LOCATION Hintonburg West  
Storm Sewer Tunnel, Ottawa

# FOUNDATION INVESTIGATION REPORT

W.P. 174-80-02

The Pavement and Foundation Design Section undertook the original geotechnical investigation in April, 1982, and compiled the Foundation Investigation Report. As the basis of the claim is changed ground conditions, it was considered appropriate for this Section to comment on the claim by U.C.L. and on the report by the consultant to U.C.L. Mr. J. Nunan, consultant to M.T.C. is preparing separate reports on (i) his site visit, and (ii) his comments on U.C.L.'s claim.

PROP STORM SEWER TUNNEL  
(AT QUEENSWAY & CARLING AVE)  
BORE HOLE LOCATIONS & SOIL STRATA

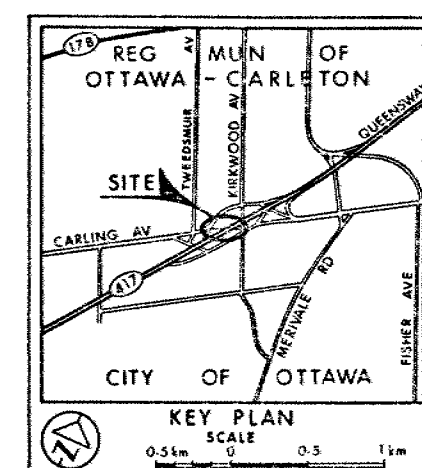
"M.T.C. DID NOT ANTICIPATE HIGH WATER INFLOWS" - In the Foundation Investigation Report, Drawing No. 174-80-02 indicates distinctly a zone of very poor rock in the vicinity of Borehole 5, from bedrock surface down to tunnel elevation. Zones of higher permeability should have been anticipated by the subcontractor in this section of the tunnel. In addition, soil overlying bedrock is generally granular in nature, and direct hydraulic communication to this very poor rock mass should have been anticipated. This is, in fact, the section of tunnel in which zones of high inflow were encountered during tunnelling. In addition, the Foundation Investigation Report, pg. 9, says "Local grouting of intensely jointed sections may be necessary to seal these fractures", suggesting such zones could be anticipated.

Pg. 3, paragraph 3: RAK ALSO CONCLUDES "THAT THERE IS NO EVIDENCE IN THE FOUNDATION INVESTIGATION REPORT THAT HEAVY INFLOWS COULD BE INFERRED OR ANTICIPATED". As previously stated in this report, Drawing No. 174-80-02 in the Foundation Investigation Report clearly indicates a zone of very poor to poor rock in the vicinity of Borehole 5. Zones of higher permeability should have been anticipated by the contractor in this section of the tunnel. In addition, pg. 9 of the Foundation Investigation Report states "Local grouting of intensely jointed sections may be necessary to seal these fractures", indicating such zones could be anticipated.

Pg. 5, paragraph 4: "THERE IS NO EVIDENCE IN THE FOUNDATION INVESTIGATION REPORT THAT HEAVY INFLOWS COULD BE INFERRED OR ANTICIPATED. As discussed previously, Drawing No. 174-80-02 in the Foundation Investigation Report clearly indicates a zone of very poor to poor rock in the vicinity of Borehole 5. Zones of higher permeability should, therefore, have been
